DEVELOPMENT ASSESSMENT REPORT	
Application No.	DA/2021/0266
Address	27 Hercules Street ASHFIELD NSW 2131
Proposal	Strata subdivision of an existing 2 storey commercial building
Date of Lodgement	21 April 2021
Applicant	Sky Town Planning
Owner	Proprietor of Company Title
Number of Submissions	Nil
Value of works	\$0.00
Reason for determination at Planning Panel	Heritage Item without agreement that works can proceed
Main Issues	Impact on Heritage Item Waste Management BCA Upgrades
Recommendation	Refusal
Attachment A	Plans of proposed development
Attachment B	Statement of Heritage Significance
Attachment C	BCA Report
Attachment D	Draft conditions in the circumstance the application is approved

This report is an assessment of the application submitted to Council for Strata subdivision of an existing 2 storey commercial building at 27 Hercules Street ASHFIELD NSW 2131.

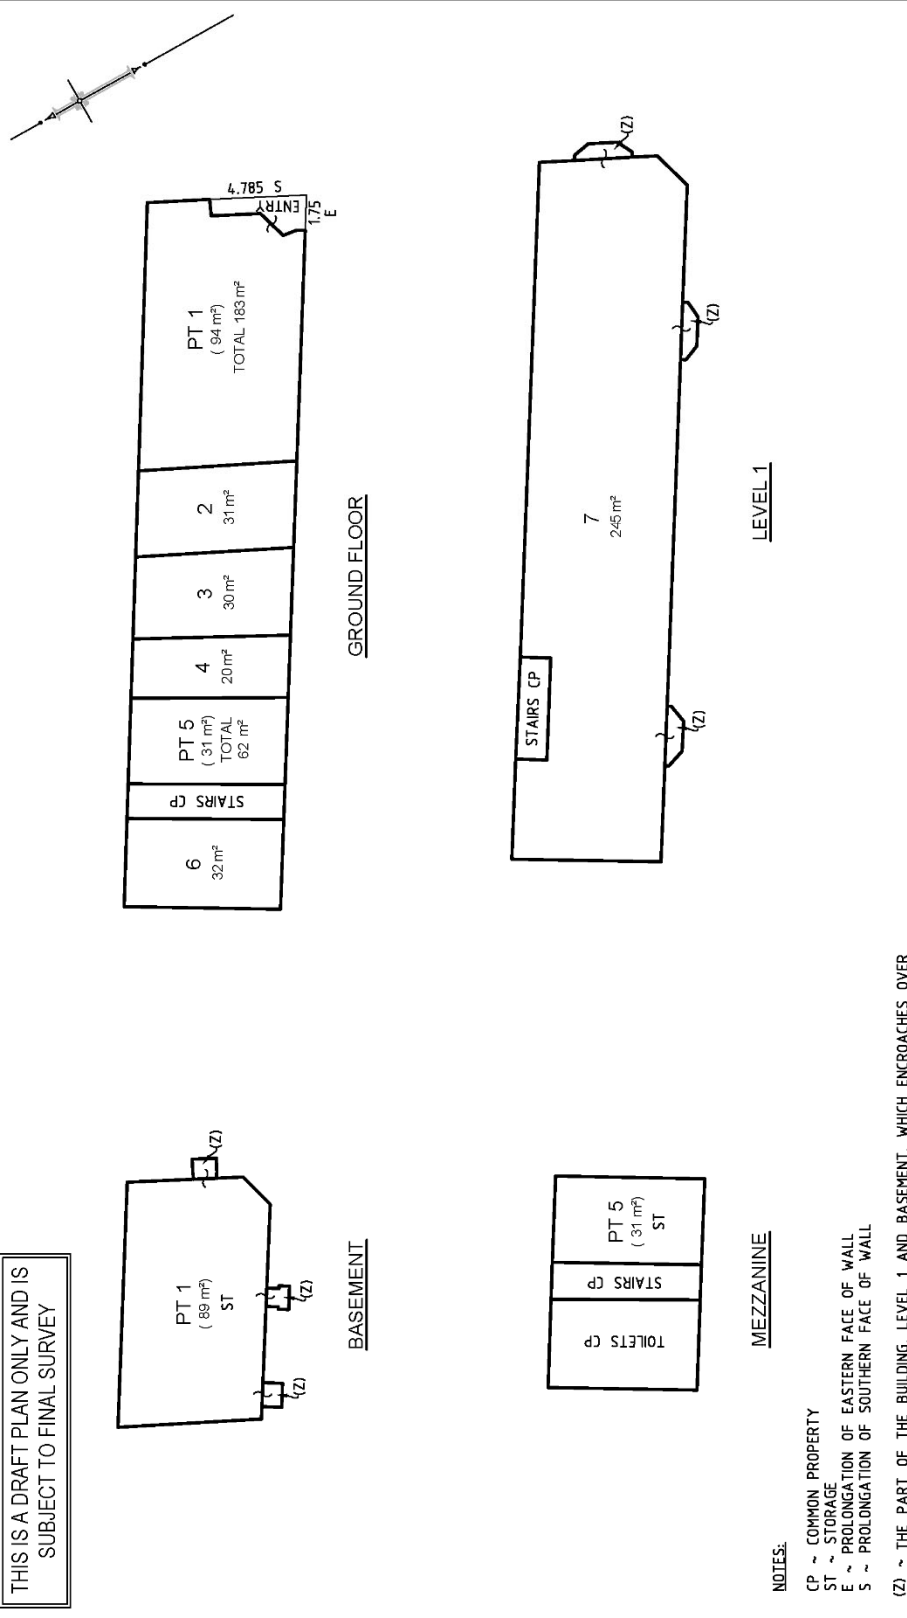
The proposal includes strata subdivision into 7 lots with additional areas dedicated for common property. Details submitted with the application identify that there is no waste storage area on site rather waste is stored on Council land in Fox Lane. As the application is for strata subdivision Council must be satisfied that appropriate waste storage is provided on site in accordance with DS6.3 and waste must be stored wholly within the site boundaries to ensure there are no impacts to the surrounding amenity. As such, the application has not demonstrated the subdivision will not adversely impact the amenity of the area as no waste facilities are provided on site.

In addition to the above, the Building Code of Australia (BCA) report submitted with the application details upgrades will be required to the existing building to meeting the BCA standards. The report details the upgrades including ramps to be demolished, installation of balustrades and handrails and inclusion of non-habitable areas within the existing building. No demolition, existing or proposed plans have been submitted with the application to confirm the changes that will be undertaken and proposed use of spaces. Architectural plans were requested to illustrate the changes however they were not submitted. Therefore, the application has not adequately demonstrated that the proposal will meet the requirements of the BCA and inadequate information has been submitted with the application to thoroughly assess the proposed strata subdivision.

In addition to the above, the proposal includes strata subdivision of an existing heritage item. Part 7.1 of Chapter E1 contains objectives and controls to ensure subdivision of heritage items does not affect their significance. It is considered that strata subdivision of the subject site is inconsistent with the relevant objectives and controls as it will impact on the setting of the Heritage Item and may result in inconsistent presentation of the façade. This is due to a portion of the building above the awning being proposed as part of Lot 5 and common property with the rest of the building above the awning being proposed as Lot 7.

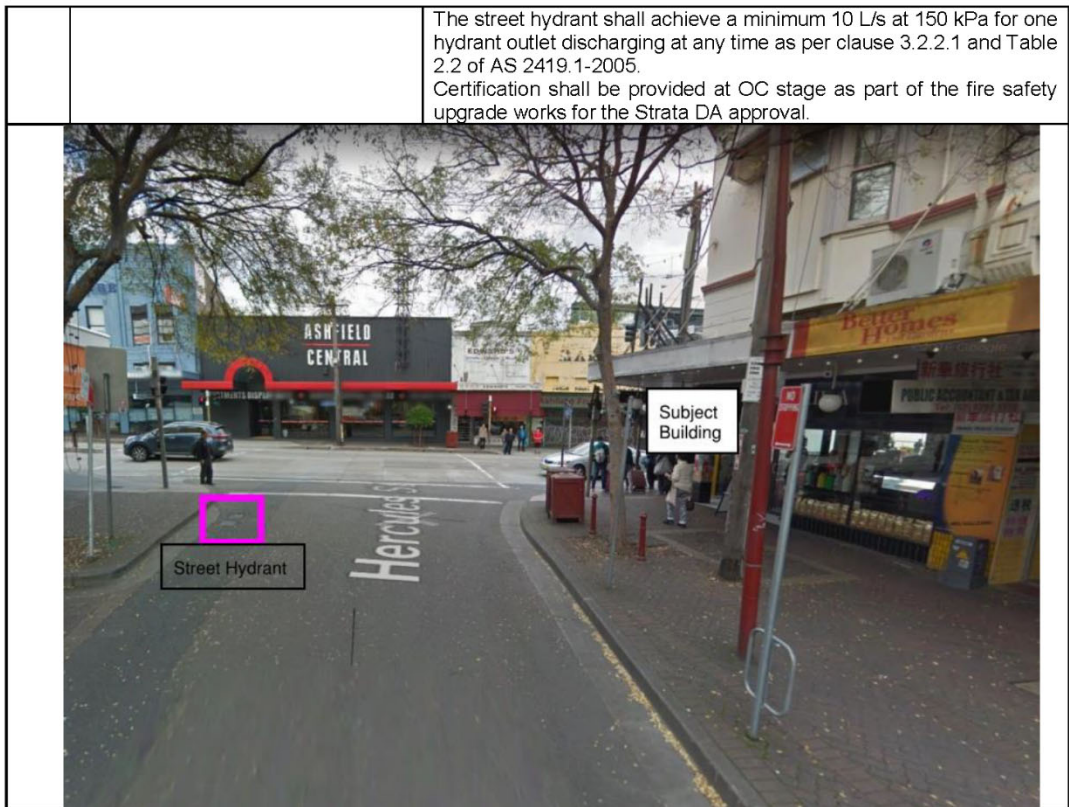
Category 1 Fire Safety Provisions	Comment / Upgrade Works
13.	EP1.3 – BCA2019 Clause E1.3 The building is served by an external fire hydrant in the north-west corner of the site.	<p>The building has a floor area greater than 500 m² (measured at 514m² including ground & first floor, mezzanine and basement under café) therefore it must be served by a fire hydrant system complying with AS2419.1-2005.</p> <p>Coverage can be provided in accordance with AS 2419.1-2005 from the street hydrant when a 60m hose is connected to the FRNSW pumping appliance.</p>
